Safety Evaluation Report

related to the operation of
**Grand Gulf Nuclear Station,
Units 1 and 2**

Docket Nos. 50-416 and 50-417

August 1984

Figure 13.3 Unit organization

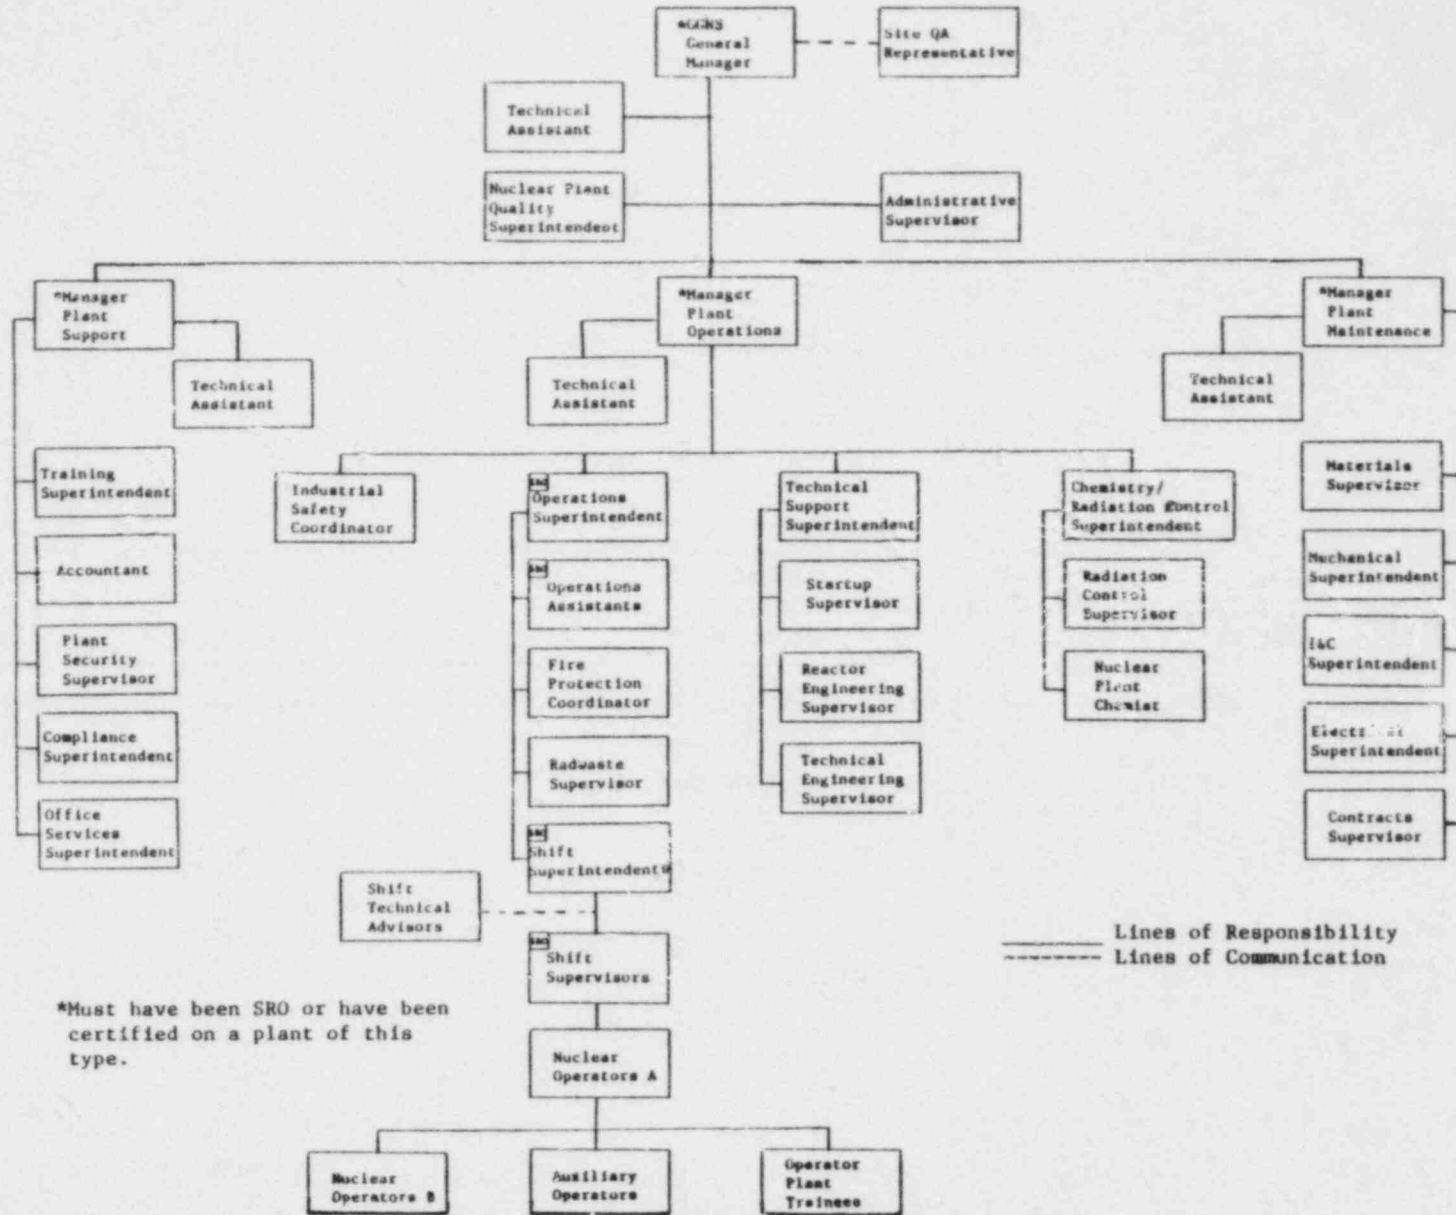
By letter dated May 24, 1984, the licensee informed NRC that there have been significant changes made to the plant organization. The new organization is shown in Figure 13.3. The Grand Gulf General Manager reports to the Vice President, Nuclear Operations.

formed and the selected individual will report directly to the Manager, Plant Support. This employee (position not shown on the organization chart) will assume the duties of the Nuclear Records Administrator. Until this new position is finalized, the Nuclear Records Administrator retains responsibility for records management and is reporting on an interim basis to the Vice President, Nuclear Support. The NRC staff considers the new arrangement to be superior to the old and concludes that it is acceptable.

Figure 22.1 Calculated equipment temperatures where $\dot{M}_{H_2} = 24 \text{ lb/min (0.4 lb/sec)}$

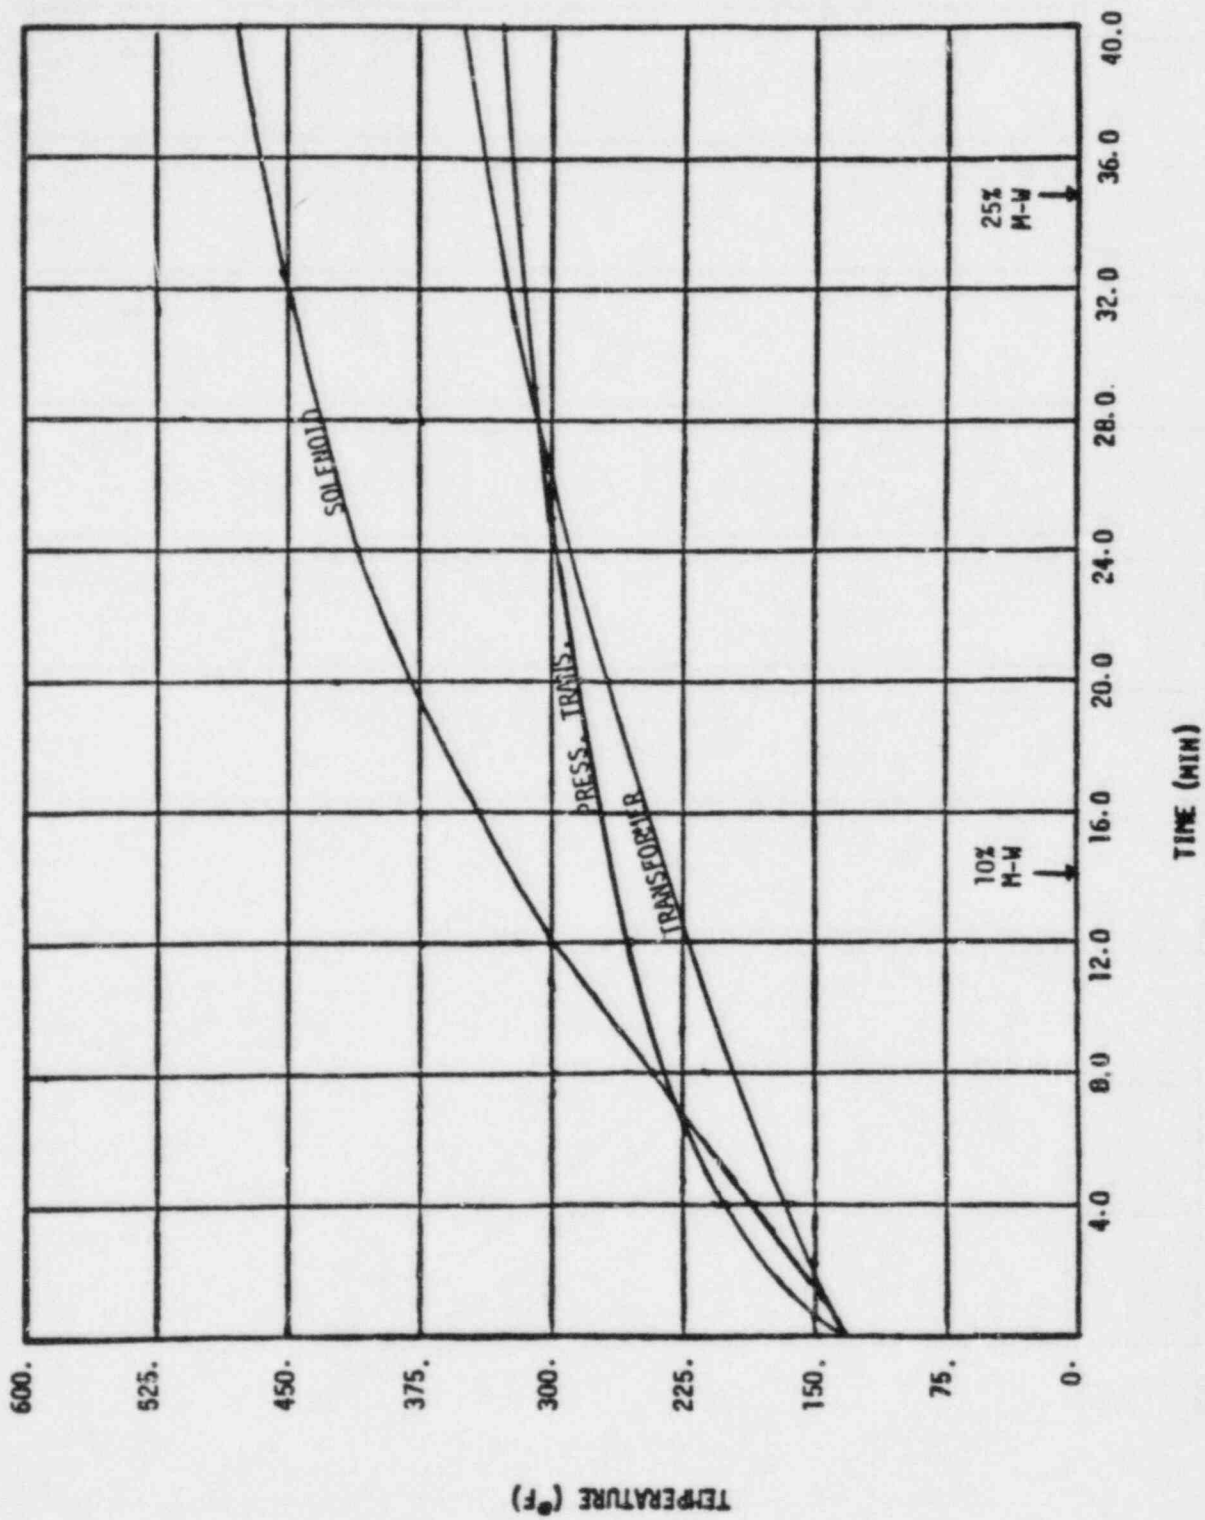
As discussed in more detail in the next section, it is the licensee's position that because of the limitations inherent in the physical process, degraded core accidents are not likely to result in a sustained hydrogen release rate of 0.4 lb/sec for more than approximately 8 min. For a hydrogen release rate of 0.8 lb/sec, the time interval would be smaller. Thus, on the basis of equipment analyses demonstrating the capability of equipment to withstand hydrogen diffusion flames for 15 to 26 min, the licensee states that essential equipment in the wetwell region would survive in the degraded core accident environment and perform its intended function.

The staff has considered the analyses provided by the licensee to evaluate equipment survivability and has found that there is uncertainty regarding the methodology for determining applicable heat fluxes as well as uncertainty in interpreting the benefits of containment sprays. Therefore, the staff will require that further temperature response analyses be performed by the licensee.
